435 DEXTER

June 18, 2014
Design Review
Recommendation
DPD Project# 3016347

DESIGN ALTERNATIVE C (PREFERRED)

SITE/GROUND FLOOR PLAN

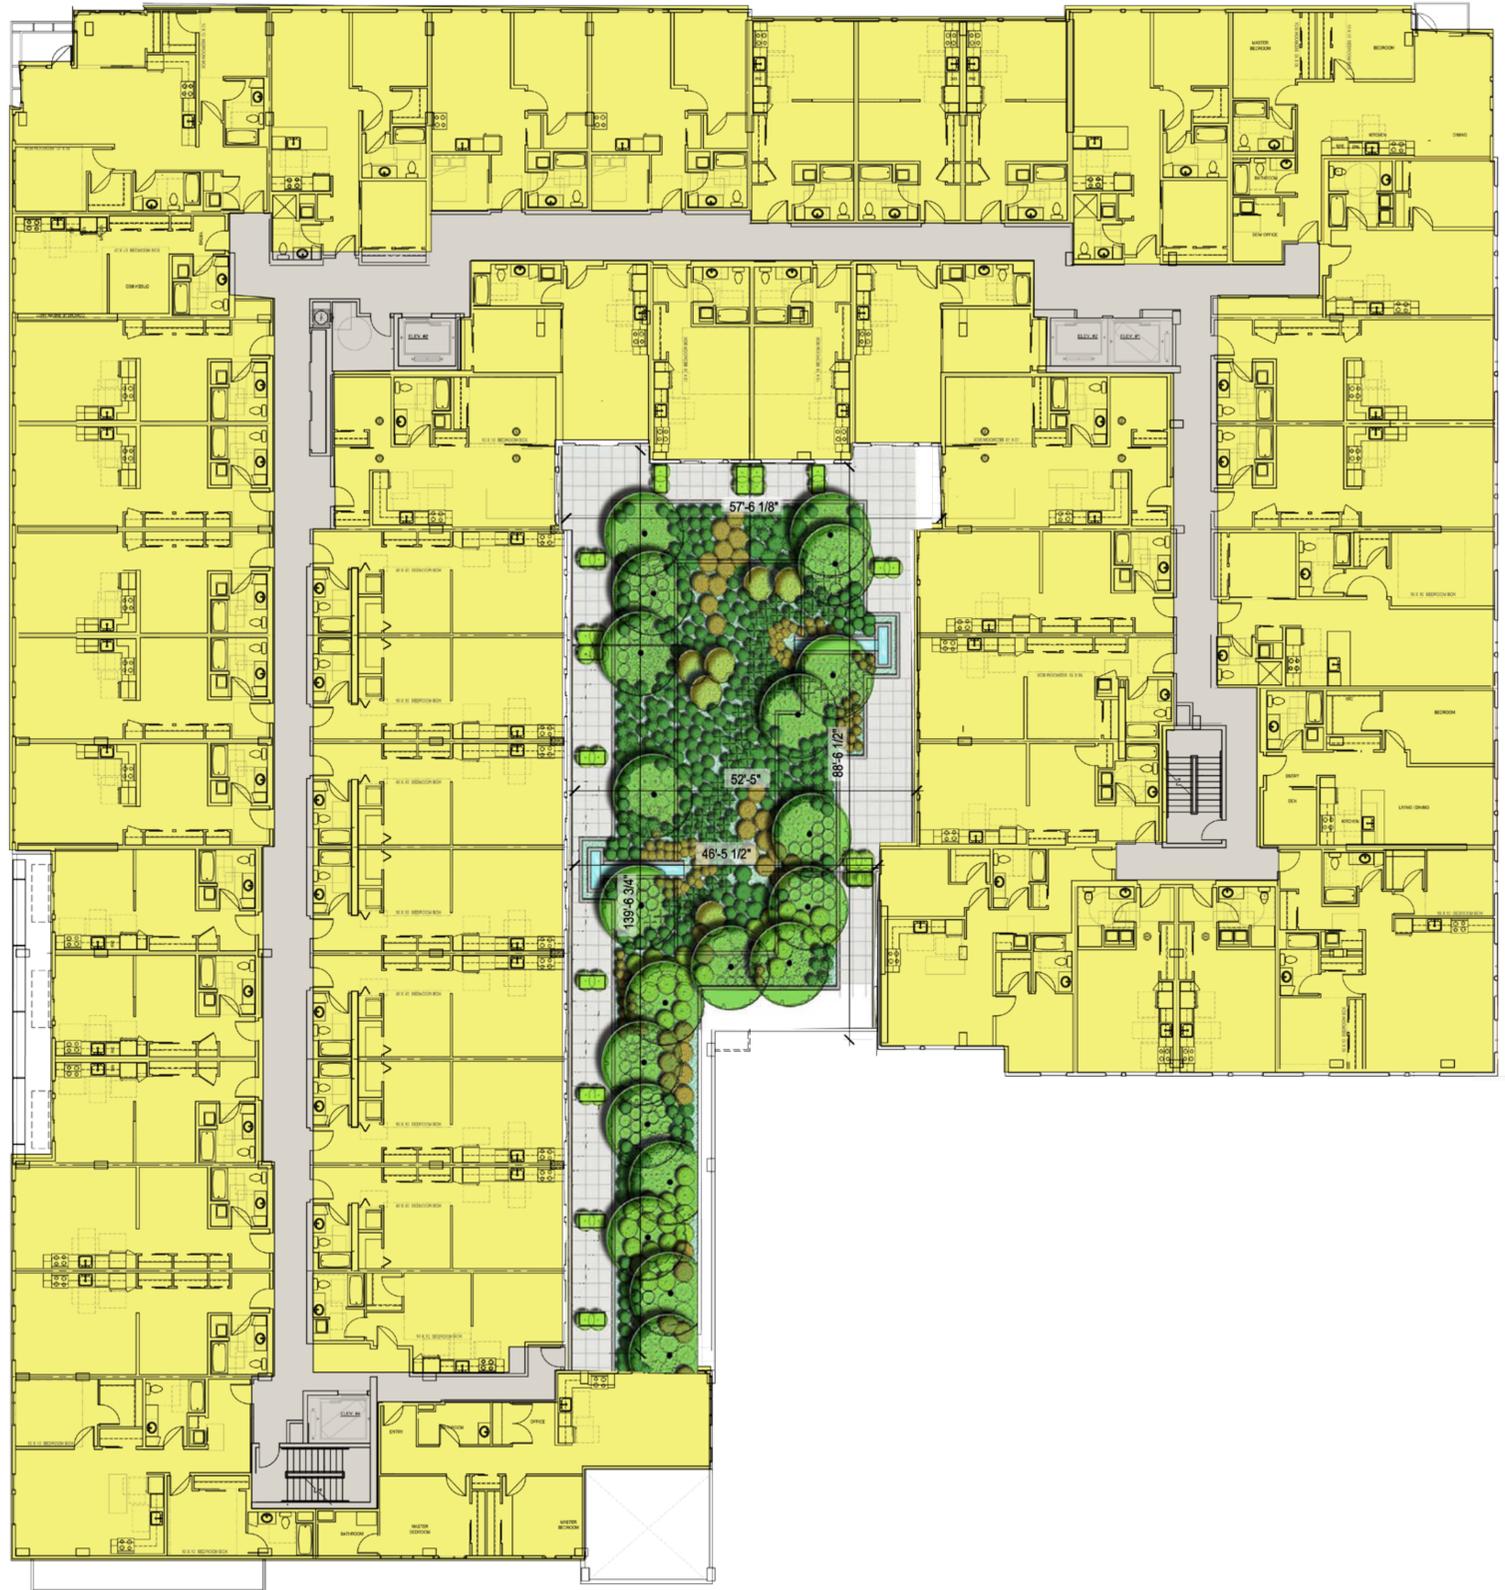
- The landscaping should be designed to enhance the site and proposed design.
- Paved areas should be designed to clarify primary entry and pedestrian areas (such as those on the east or north edges) and discourage non-residential access of residential-only entries (such as those on the west street frontage).

- Landscaping will be provided at the podium level, visible from the alley.
- Main lobby entry and adjacent right-of-way will feature special paving as well as landscaping to provide a welcoming front door to the building.

COURTYARD AT L2

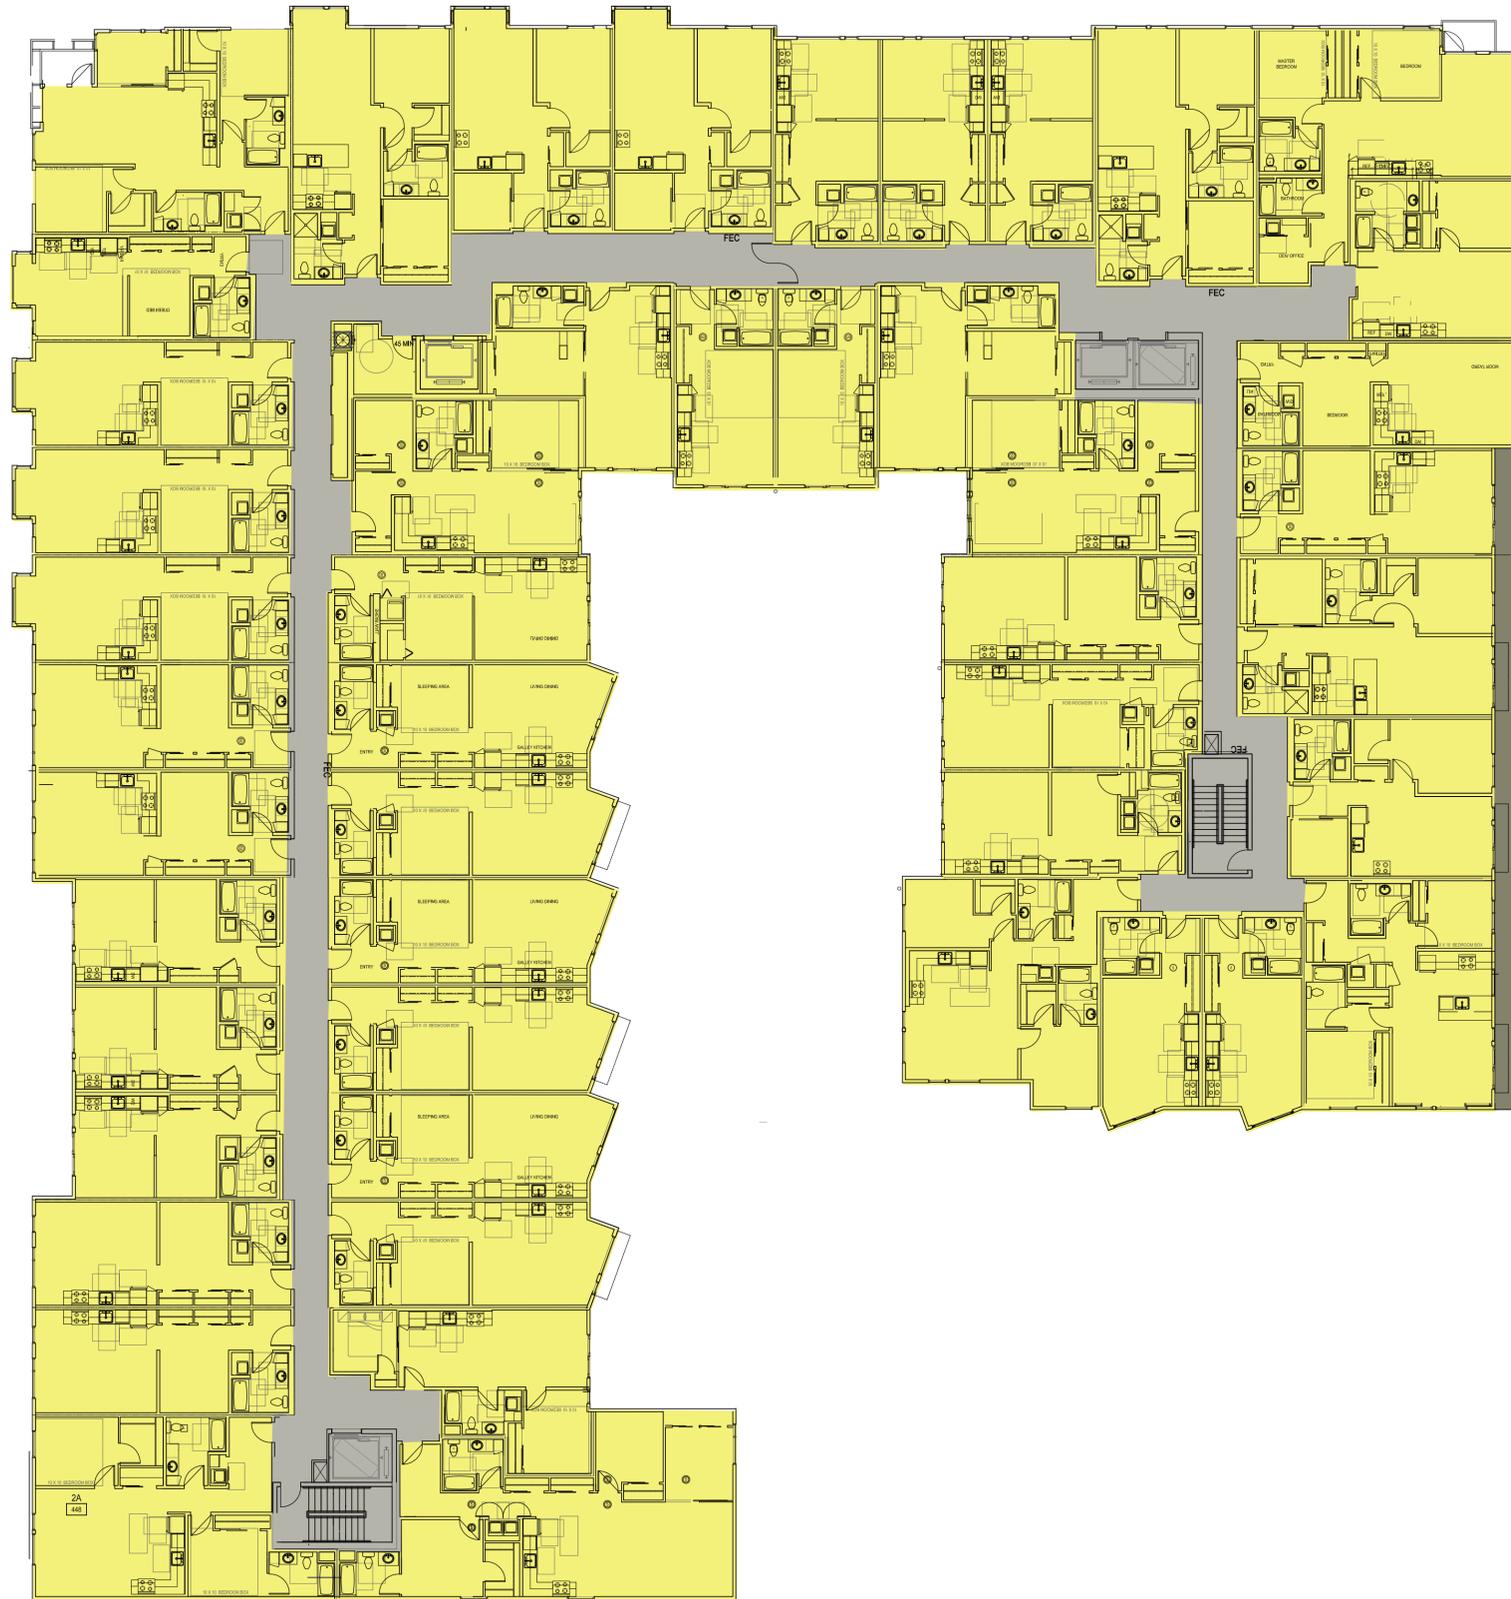
- Recommend making courtyard as wide as possible

- Courtyard is as wide as possible while accomodating residential uses along the property lines and a setback along Dexter

STREETSCAPE AT DEXTER: RESIDENTIAL ENTRIES/ PATIOS

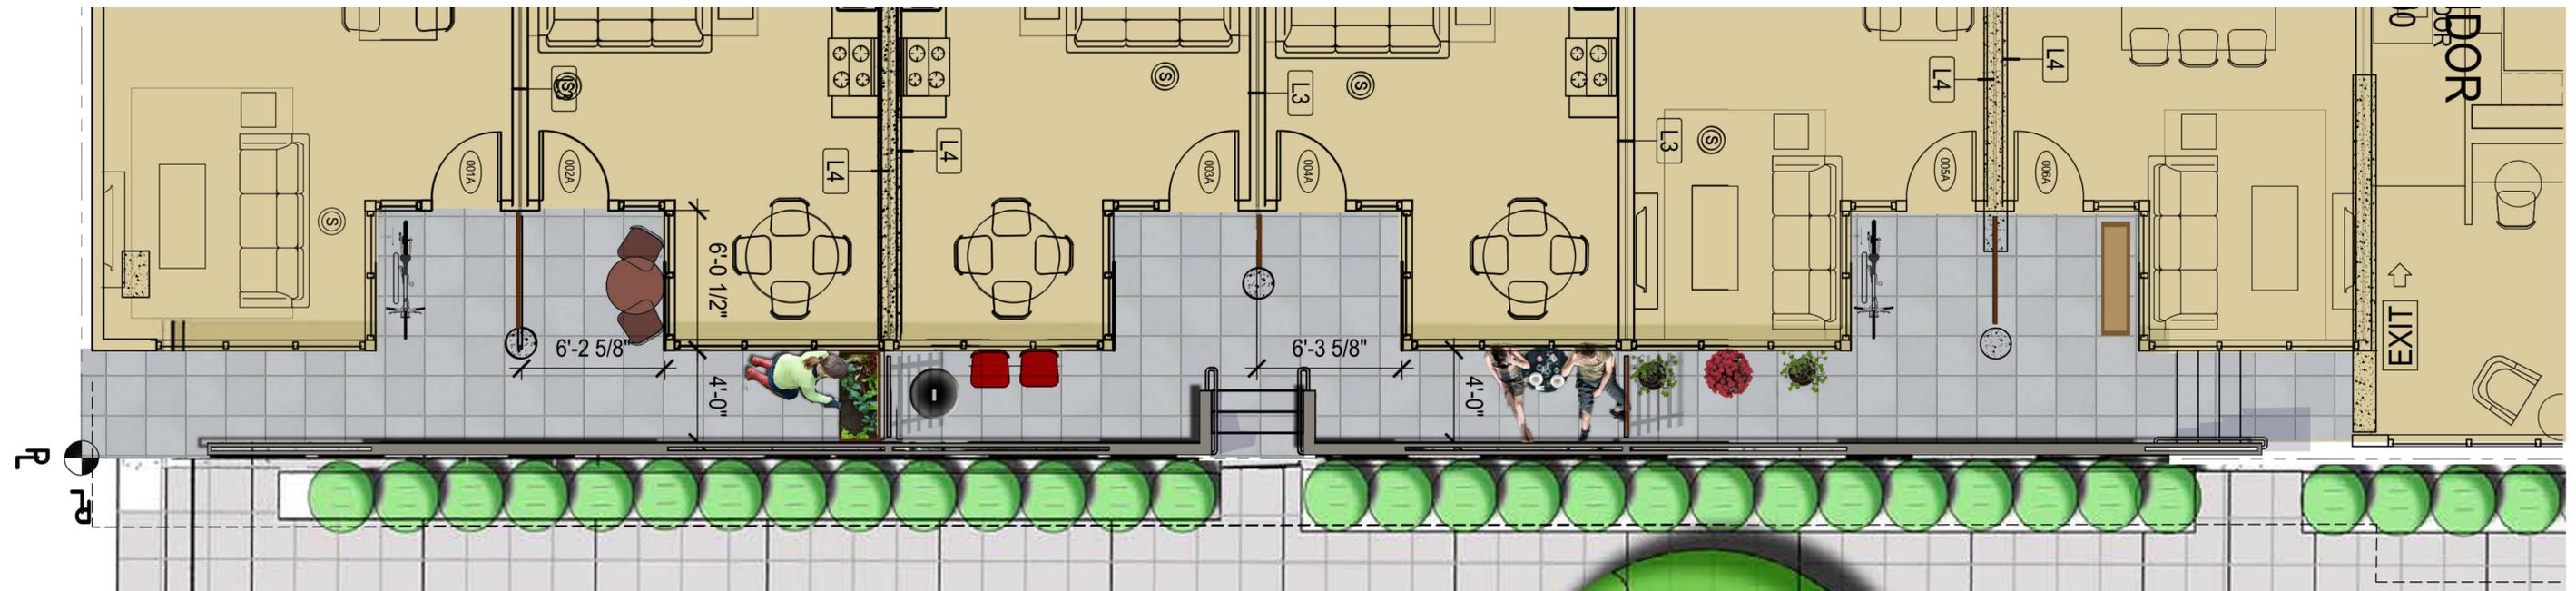
- The residential units on Dexter Ave N should be designed for flexibility to function as live-work or commercial uses in the future.
- The residential stoops and landscaping should be designed to provide usable patio areas in addition to landscaped areas. The Board indicated approximately 6'x 6' paved area is expected for patios.
- Dexter Ave N façade should be designed for human scale.

- The residential entries along Dexter have been developed to have a more commercial appearance.
- The entrances and walls facing Dexter are pulled back to create privacy from the street while maintaining visibility to the sidewalk. Extensive storefront glass appropriate for both residential and commercial uses. Patios occupy the space between the exterior walls and the property line.
- Landscaping, including street trees, will be used to provide privacy for adjacent residents and an attractive pedestrian environment.

STREETSCAPE AT SR 99: GARAGE SCREENING

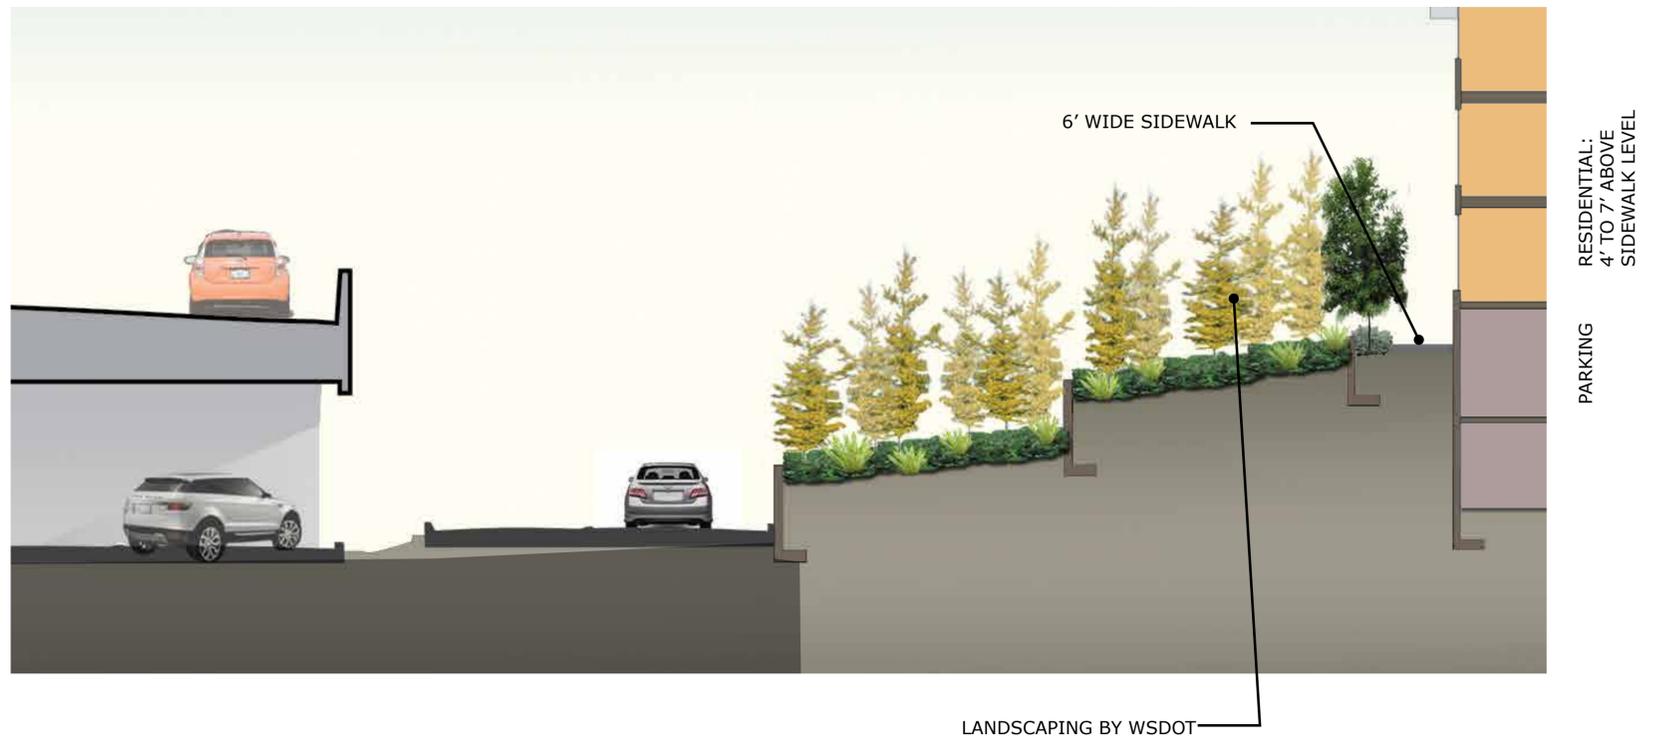
Departure: SMC 23.48.034 Screening & Landscape Standards

Due to topographic conditions, parking is permitted in stories partially above and partially below street-level without being screened by other uses if screening street-facing facade is enhanced by architectural detail, landscaping, or similar features with visual interest

Zoning review from DPD determined that proposal as designed does not meet the screening standards without more extensive use of landscaping and/or decorative panels.

Material changes, vertical plantings, and decorative metal screens as shown are appropriate for specific pedestrian environment and will be screened from SR 99 by ROW plantings and railings. Additional decorative elements would clutter the facade design and dilute the design concept

ALLEY TREATMENT

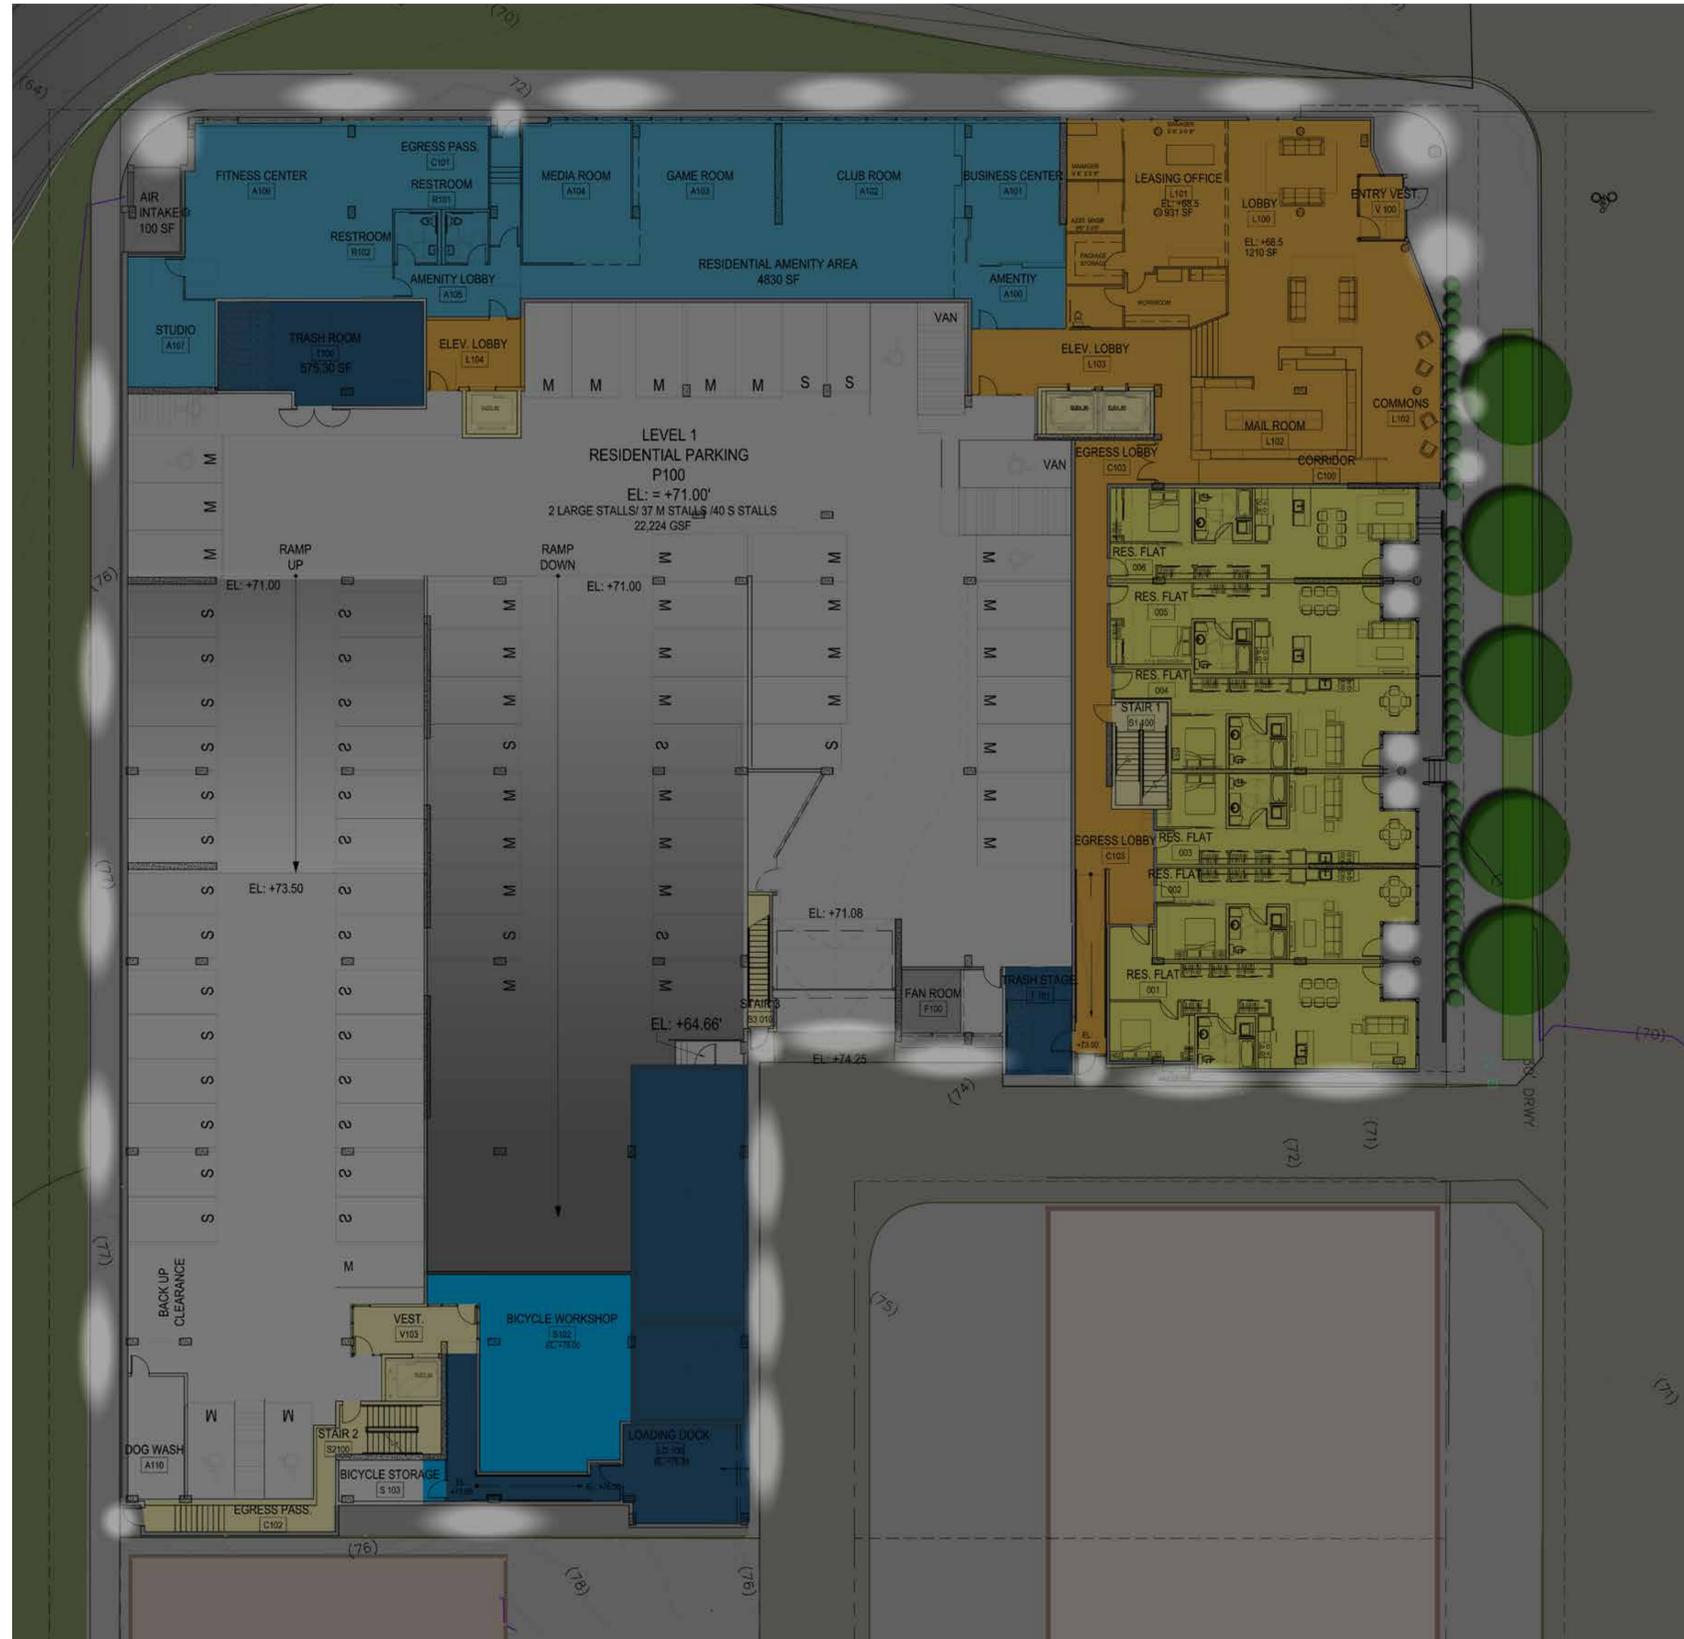
- The building edge at the alley exit to Dexter Ave N should be designed for clear sight lines.
- Alley should be designed for pedestrian safety using lighting and other techniques.
- Solid waste storage should be located to provide ease of collection and clear alley circulation.

- Alley will feature pedestrian lighting and will maximize sightlines from the South and the East.
- Dumpsters will be staged on-site, in a recess adjacent to the alley, on service days. Per SPU, 20 CY picked up twice/week. Dumpster staging has space for (7) 3 CY containers
